Brunswick County Courthouse Addition & Renovations

Addendum 2

December 20, 2019

1 Third Floor Plan
A1.2 Scale: 1/8" = 1'-0"

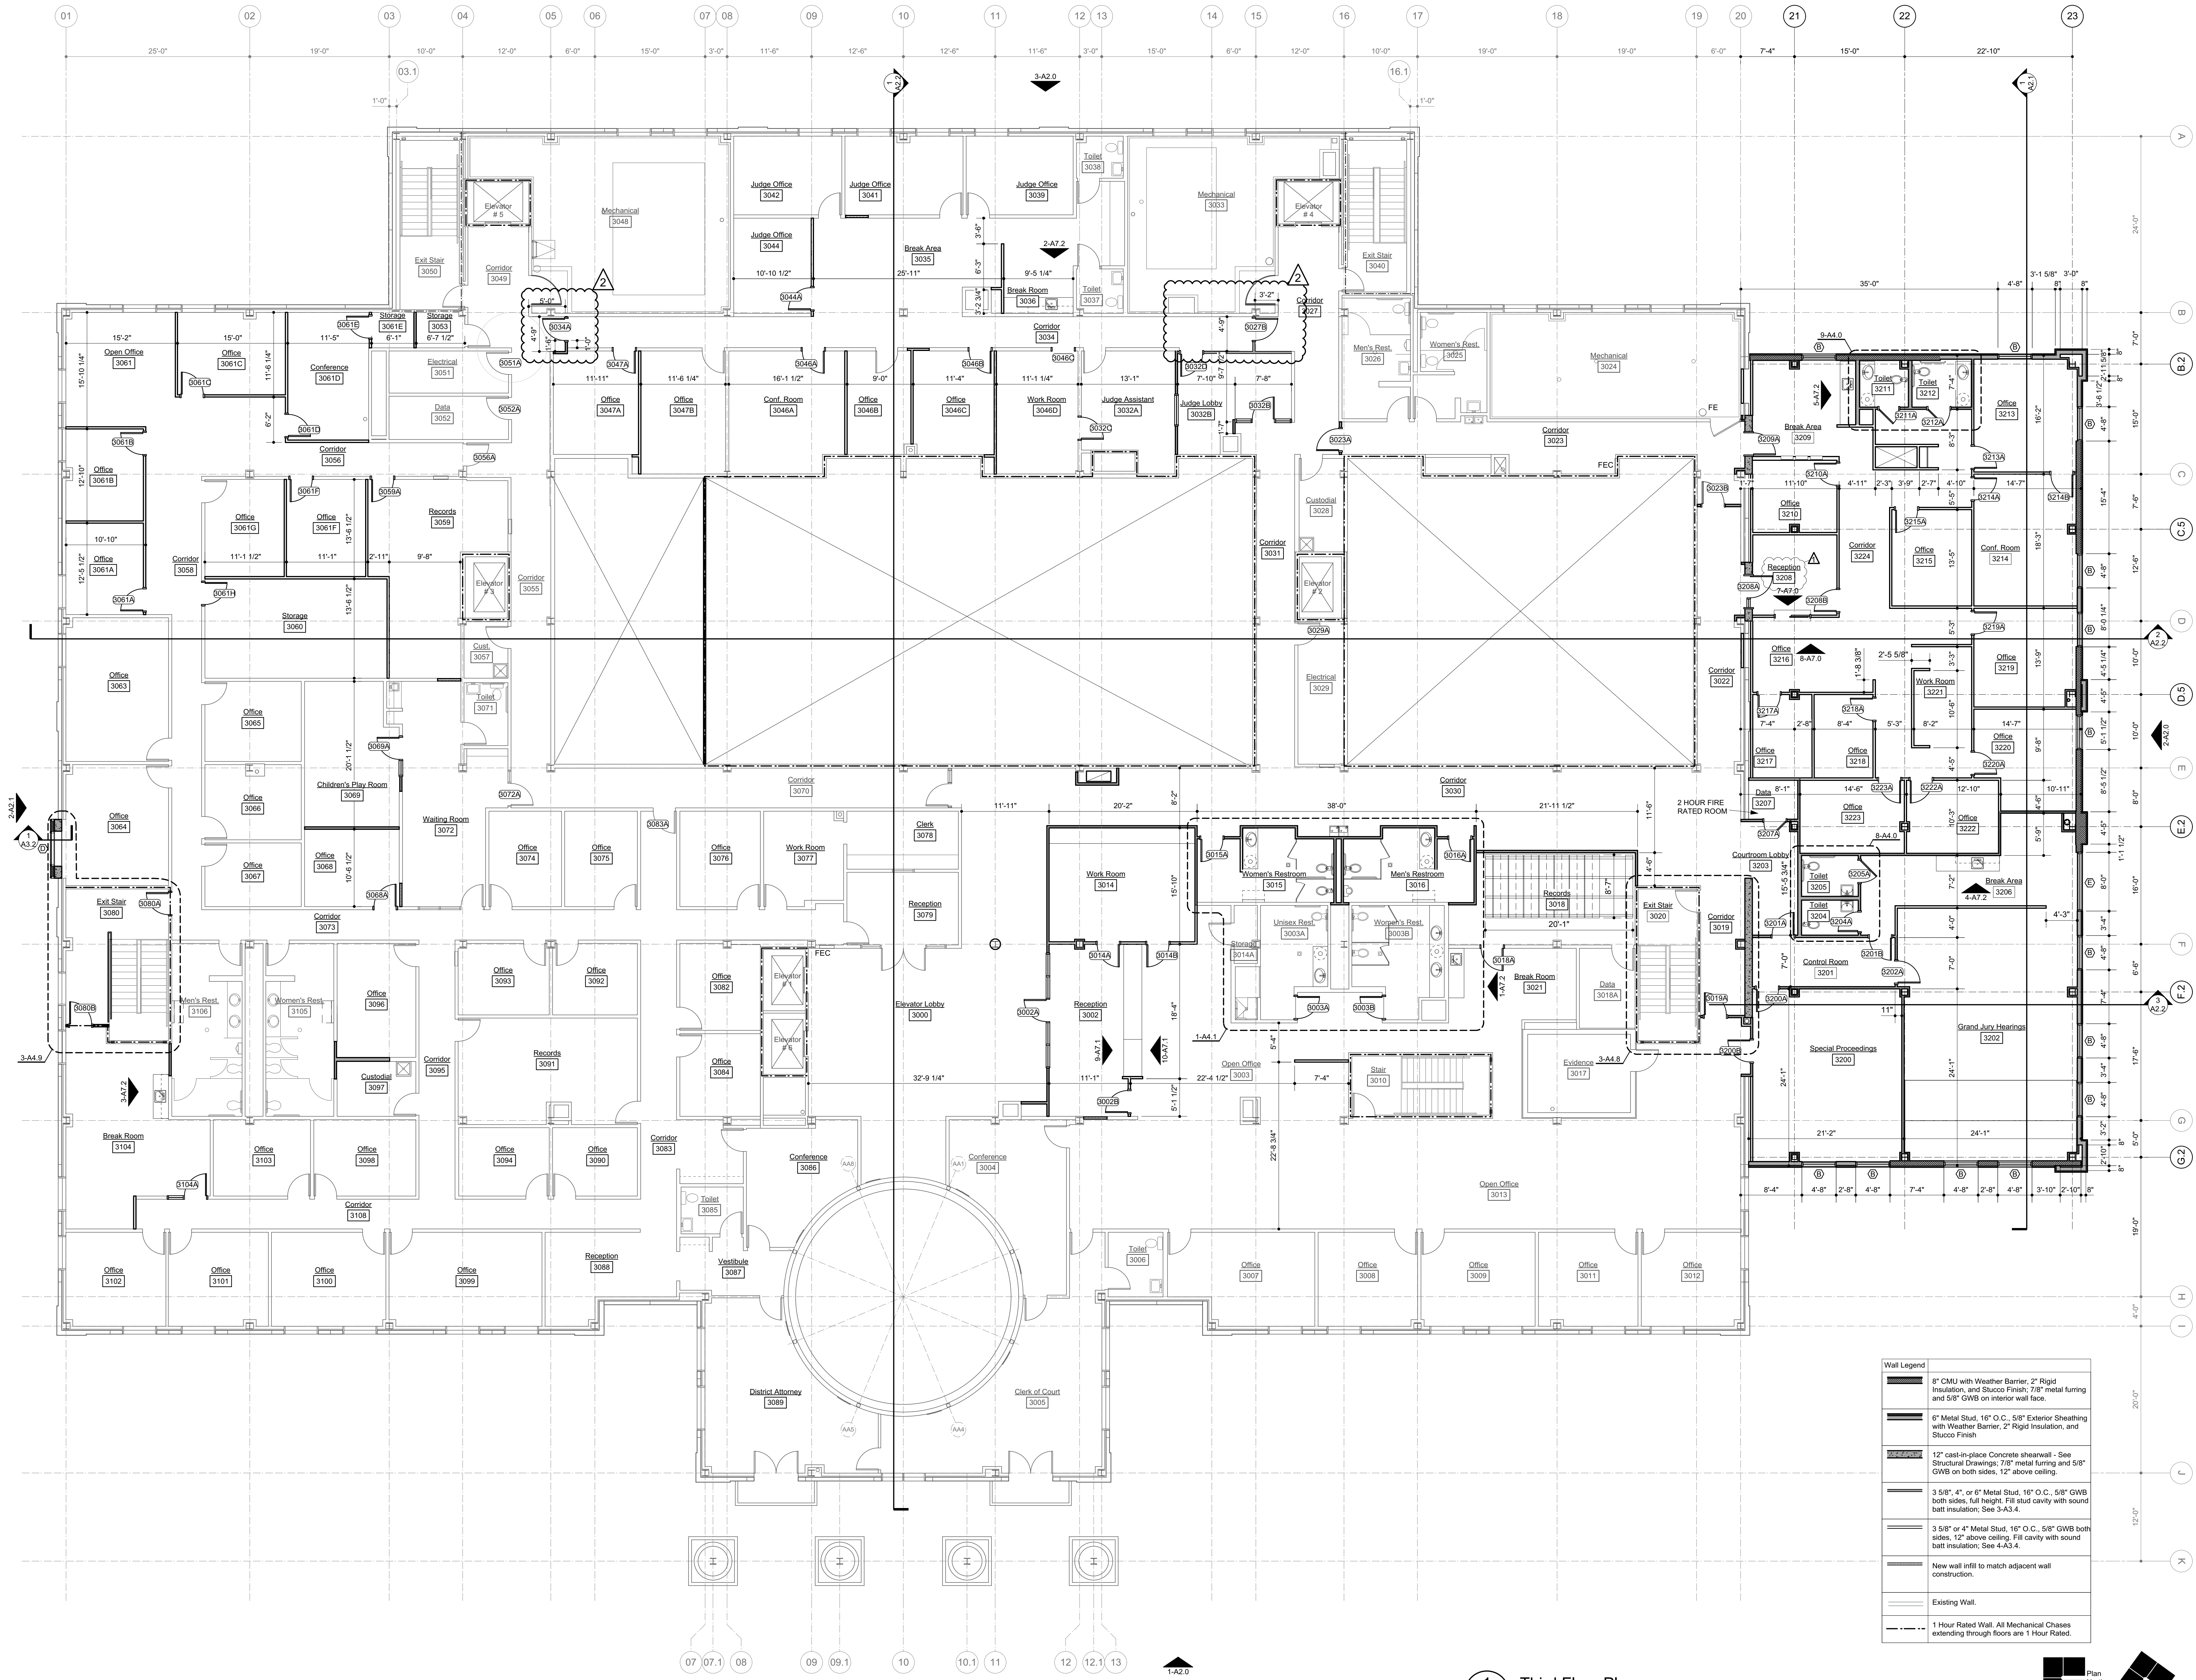
3. Cover sheet: schedule of drawings, add sheet L-1 which is in the drawing set following sheet C 2.0
4. Sheet A1.2 and A1.6 : Plan revisions have been made at door opening 3027B and 3034. Drawings are revised and enclosed.
